Project	IEEE 802.16 Broadband Wireless Access Working Group < http://ieee802.org/16 >	
Title	Enhancement of Pre-authentication of PKMv2	
Date Submitted	2004-11-15	
Source(s)	Chulsik Yoon, Mi-young Yun, and SungCheol Chang	csyoon@etri.re.kr
	ETRI 161, Gajeong-dong, Yuseong-Gu, Daejeon, 305-350, Korea	
Re:	Contribution on comments to IEEE P802.16e/D5	
Abstract	In this contribution, we propose to enhance the pre-authentication concept to the various cases of authorization modes.	
Purpose	Adoption	
Notice	This document has been prepared to assist IEEE 802.16. It is offered as a basis for discussion and is not binding on the contributing individual(s) or organization(s). The material in this document is subject to change in form and content after further study. The contributor(s) reserve(s) the right to add, amend or withdraw material contained herein.	
Release	The contributor grants a free, irrevocable license to the IEEE to incorporate text contained in this contribution, and any modifications thereof, in the creation of an IEEE Standards publication; to copyright in the IEEE's name any IEEE Standards publication even though it may include portions of this contribution; and at the IEE

Figure 1. Description of the PKMv2 Key Hierarchy

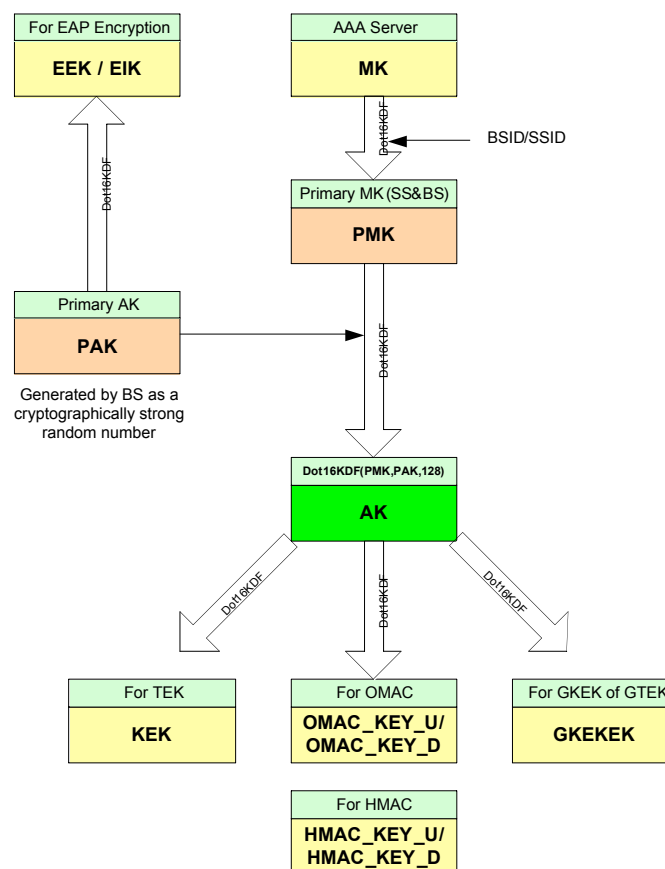
In Figure 1, I have shown the general PKMv2 key hierarchy concept.

Currently, the Pre-authentication is applied to the PMK, not PAK. In Figure 1, only the right branch of the key hierarchy tree can be applied the pre-authentication for fast handover. But for most of the cases including the left branch of the key hierarchy tree (the RSA only case, RSA with EAP yielding an MK case, and the RSA with EAP not yielding an MK case), the pre-authentication cannot be applied.

To enhance this mechanism to every case of the authentication mode, the MSS and the target BS shall share not only the MK, but also the PAK. During the HO procedure the serving BS transfer the MSS's capability information to the target BS, and then the target BS know the authorization capability of the MSS. Therefore, the MSS and the target BS can generate the same AK using the same AK generating rule for the initial network entry procedure, without PKM message transaction between them over the air.

Figure 2. Description of the PKMv2 Key Hierarchy (Following the new version of Key Hierarchy text submitted in Session #34; C802.16e-04/217r1)

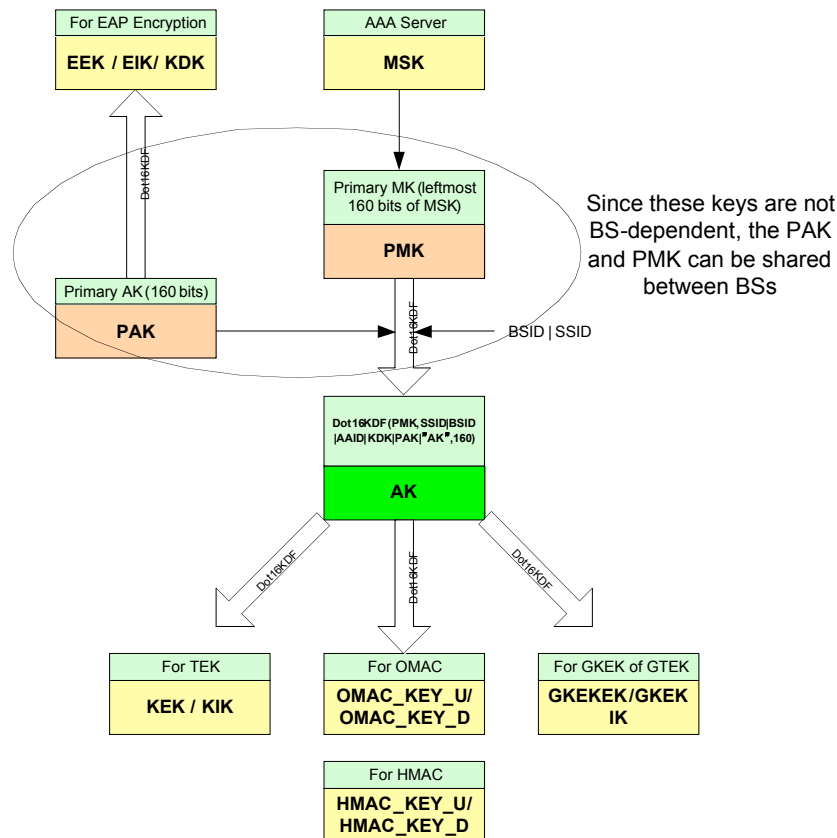
Following the new version of the PKMv2 Key Hierarchy text (C802.16e-04/217r1) submitted on session #34, proposed Pre-authentication text should be changed appropriately. It is shown in Figure 2.:

MK should be changed to PMK, and the PMK is not BS-dependent.

AK is generated by the following rule.

The PAK and the ~~MK-PMK~~ sharing method between them is out-of-scope of the specification. There can be two possible methods: 1) Transfer the ~~MK-PMK~~ and the PAK from the old serving BS to the target BS. 2) ASA server (including the AAA server conceptually) distribute the same MK and PMK to the target BS.

If the target BS get the ~~MK-PMK~~ and the PAK, then the MSS and the target BS can derive the same AK between them using the ~~MK-PMK~~, PAK, and SSID, BSID, AAID, and KDK by the following step:
